PLANNING BOARD

Tuesday, May 9, 2023 at 4:30 PM
This meeting will be held remotely via
Zoom

- ii. Major Site Plan; 172 Bishop Street; University of New England, Applicant. The Planning Board will hold a remote workshop to consider a proposal to redevelop an existing surface parking area located at 172 Bishop Street as an intermodal transportation facility with 344 parking spaces, 72 electric vehicle charging stations, and defined pick-up/drop-off area for the UNE shuttle. The subject property totals 19.2 acres and is zoned R-3 Residential, I-M Moderate Impact Industrial, and I-H High Impact Industrial. A project and plan summary are available for viewing on the city's CSS Portal (<https://css.portlandmaine.gov/>) by referencing Plan Number PL-002343-2023.

DESIGN: DEPT.	PROJECT: RECONSTRUCTION OF INTERMODAL TRANSPORTATION FACILITY AND PARKING
DRAWN: DEPT.	160-172 BISHOP STREET PORTLAND, MAINE
CHKD: TWS	SITE PLAN
DATE: DEC. 2022	PROJ. NO. 21-216-00
SCALE: 1" = 80'	DWG. NO. C-200

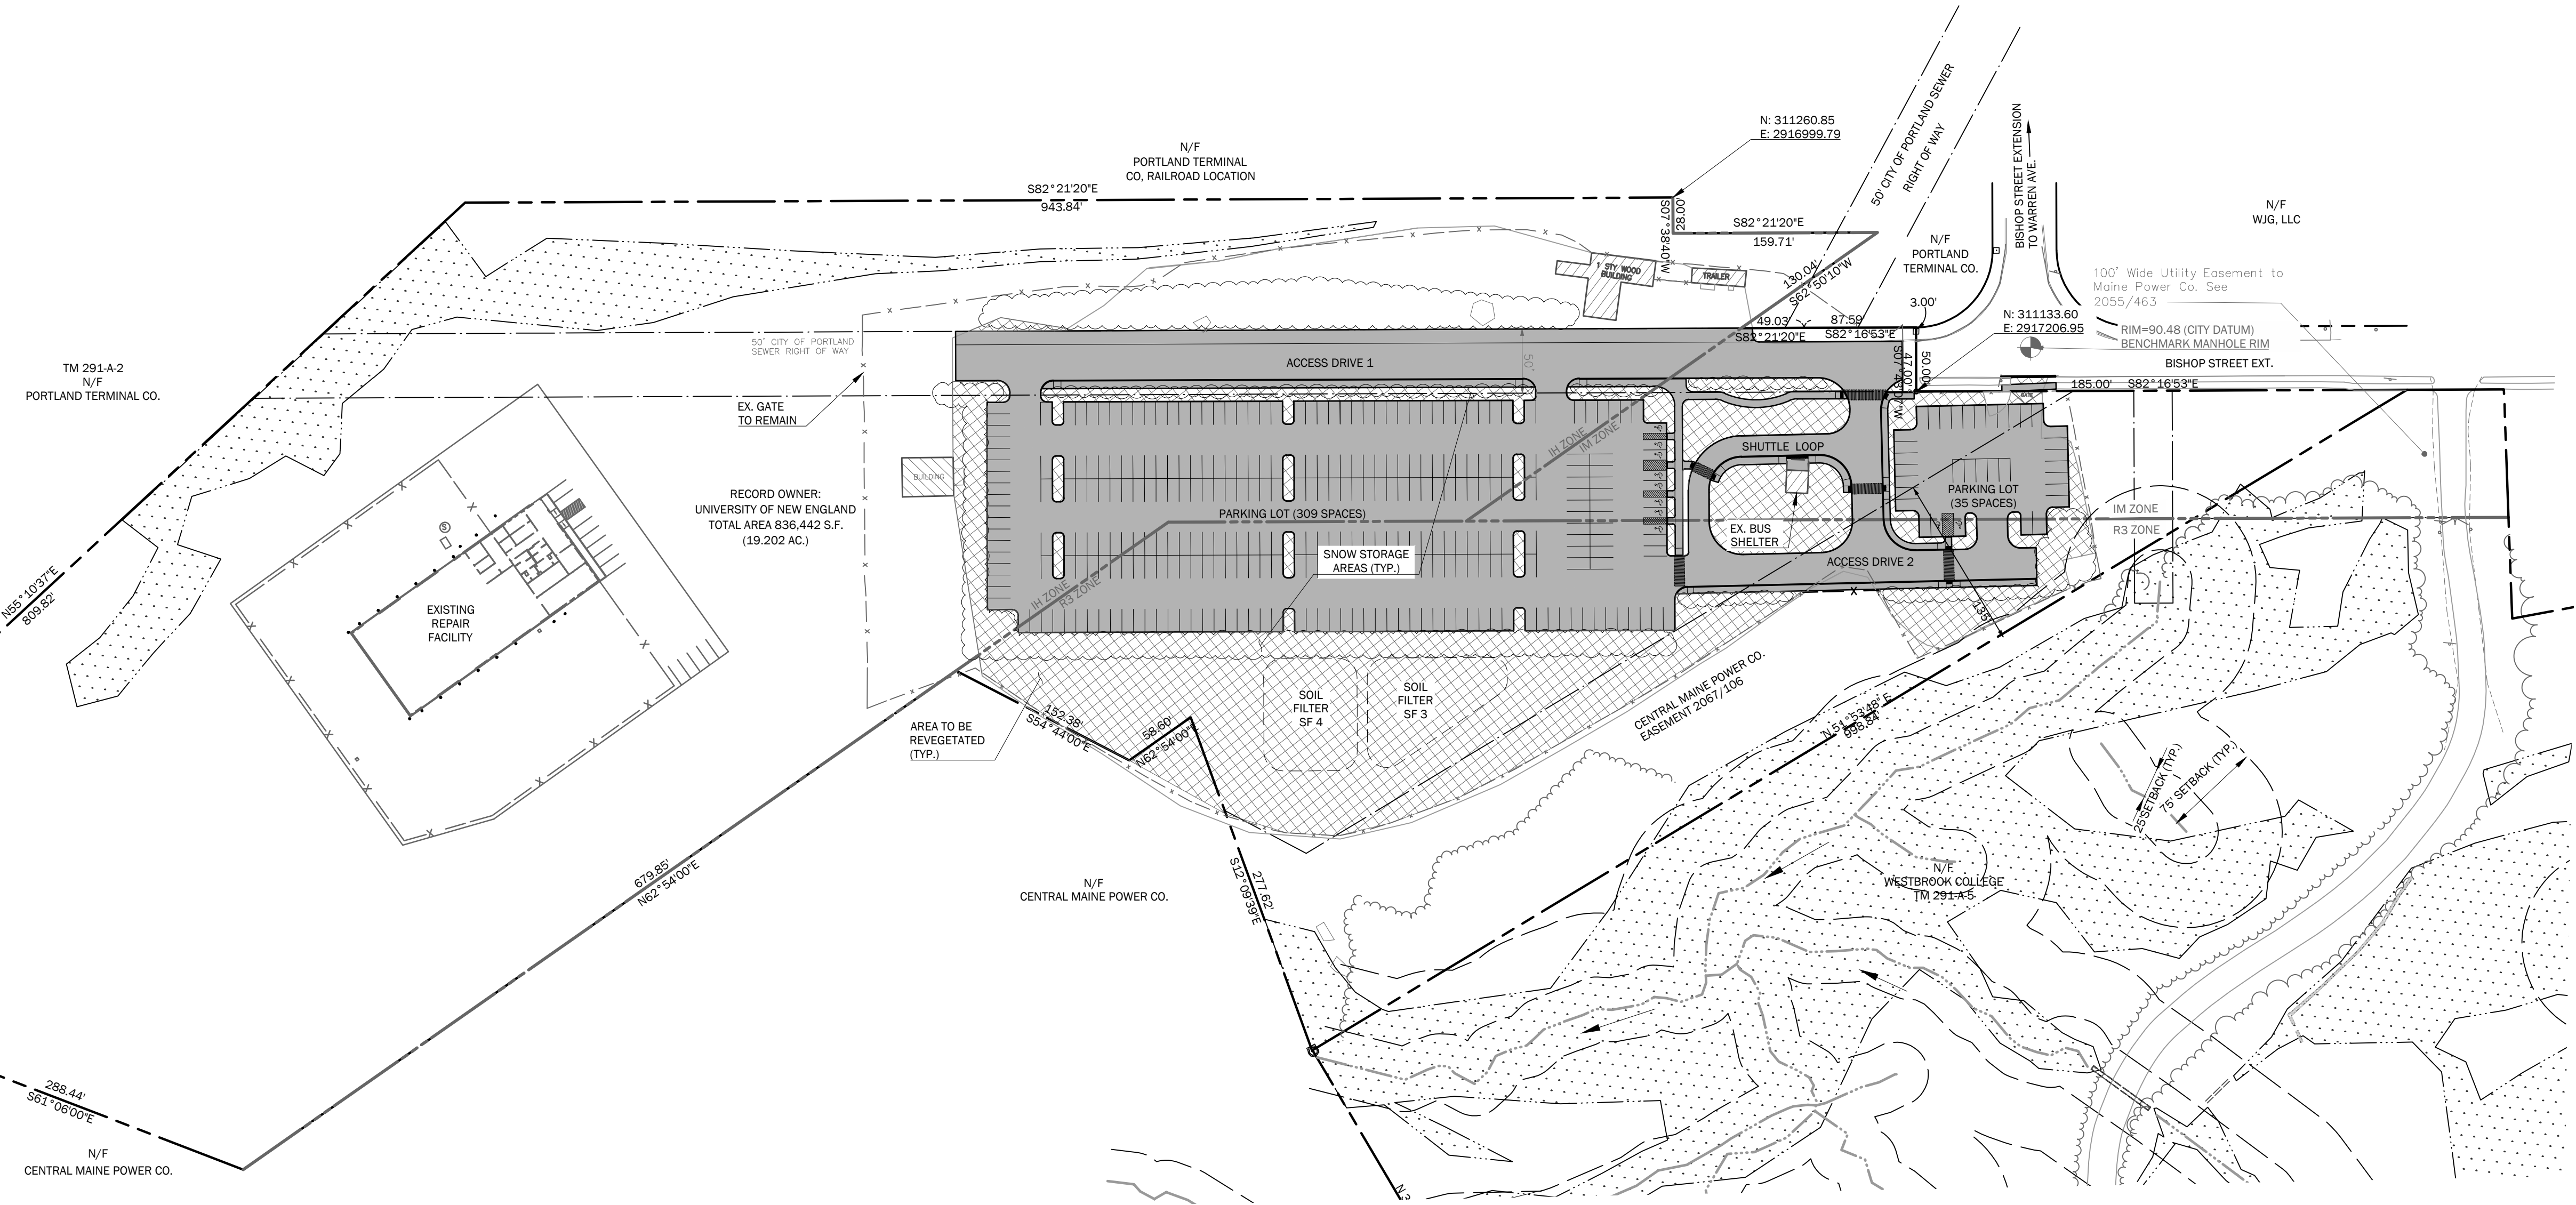
Comment: *On sheet C-200 a long stretch of parking-lot adjacent land is designated "Snow Storage Area". On Sheet L-100, this area is also identified to host dozens of new trees. There is a conflict of use with this zone- trees will not survive if the area is being used for snow storage. In order to maintain some shading of the parking lot and the desired amount of tree canopy, the City's recommendation is to cluster the trees in focused areas along the southern edge of the parking lot, leaving some continuous gaps between plantings to serve as snow-storage areas. Some proposed trees may be shifted downslope of the parking lot. Larches and Black Gum may thrive in the wetter conditions in these lower-lying areas. See notes on L-100.*
